# PLAN SHOWING EXTENSION TO GOODWILL BOTTLING LTD. BUILDING

RE: DIESEL AND GASOLINE STORAGE TANKS AT  
GOODWILL BOTTLING, LTD., VICTORIA, B. C.

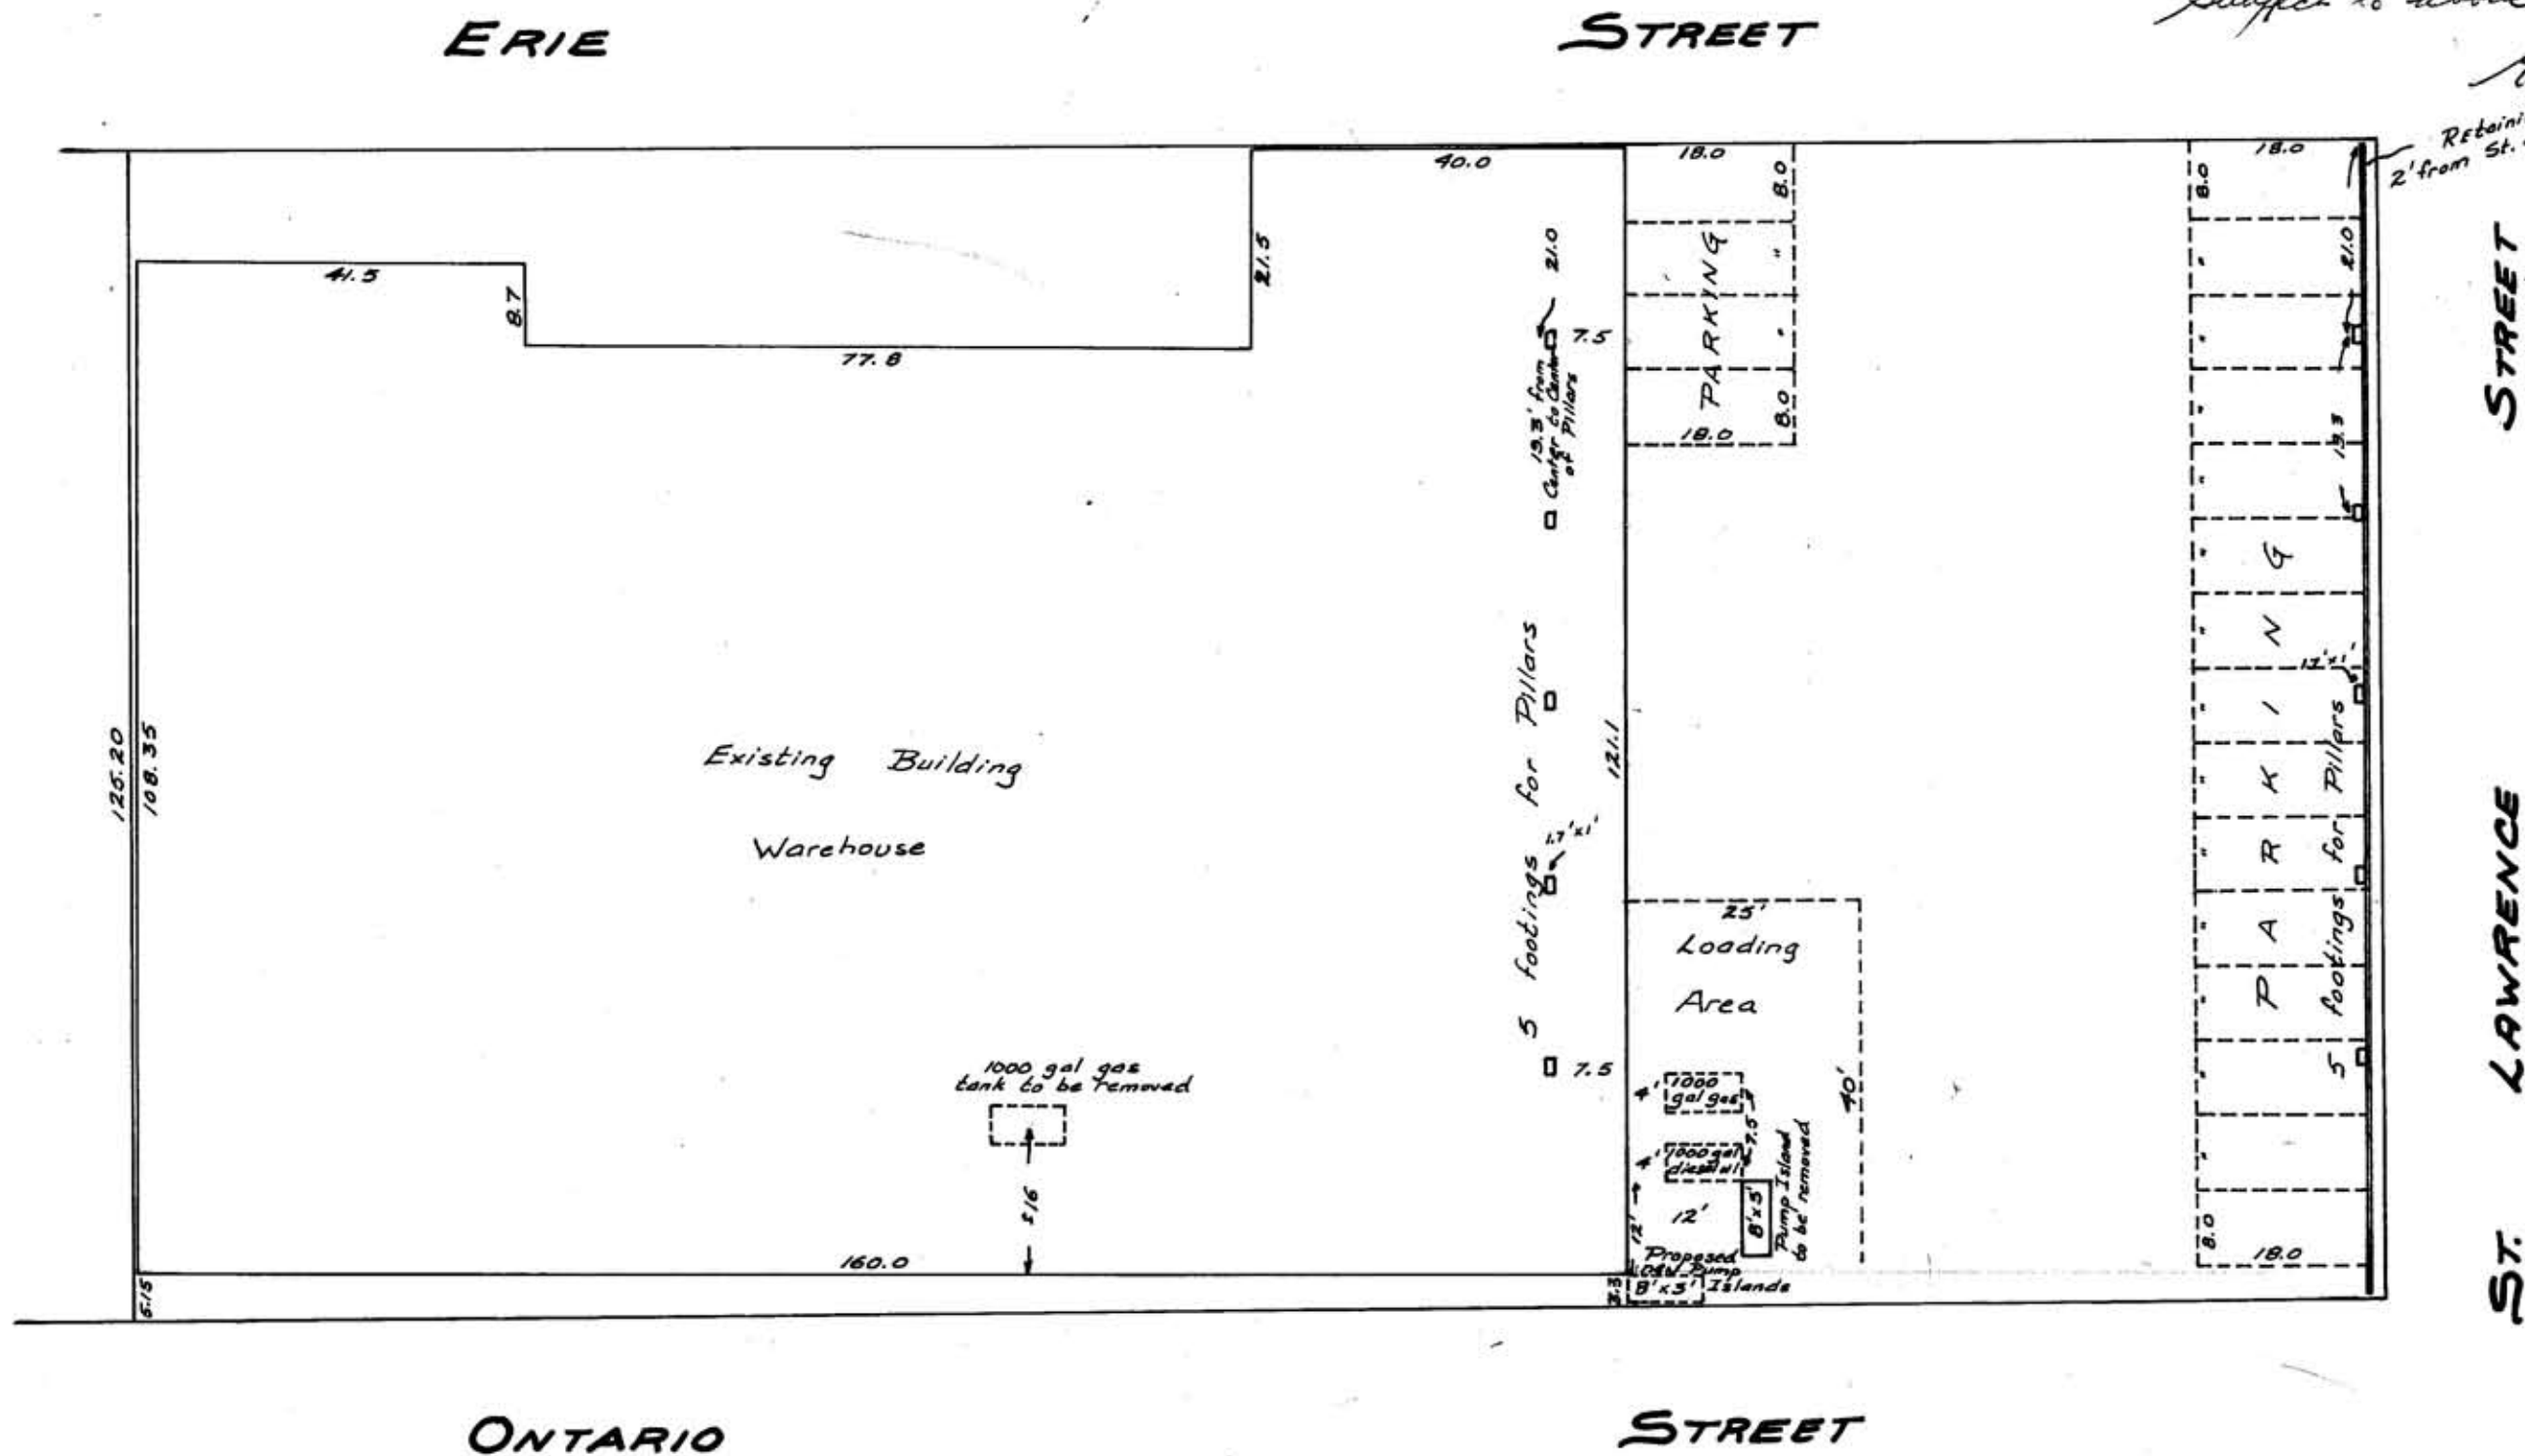
- Requirements - Fire Chief Office  
29-5-67. It is agreed Mr Goodwill will remove
1. Compressed gas installation from site;
  2. Gasoline & Diesel fluids will be dispensed from other than roadway location, in relation to position of vehicle.
  3. Vents & fill pipes to be located outside of building to approval of officer.
  4. Storage tanks location is to be in accordance with F.M. Letter Apr. 18-67.
  5. Dispensing pumps & meters to be located outside of building.
  6. All electrical work & material to meet Electrical Inspector's Approval.

**APPROVED, SUBJECT TO  
REGULATIONS MADE PURSUANT  
TO THE FIRE MARSHAL ACT.**
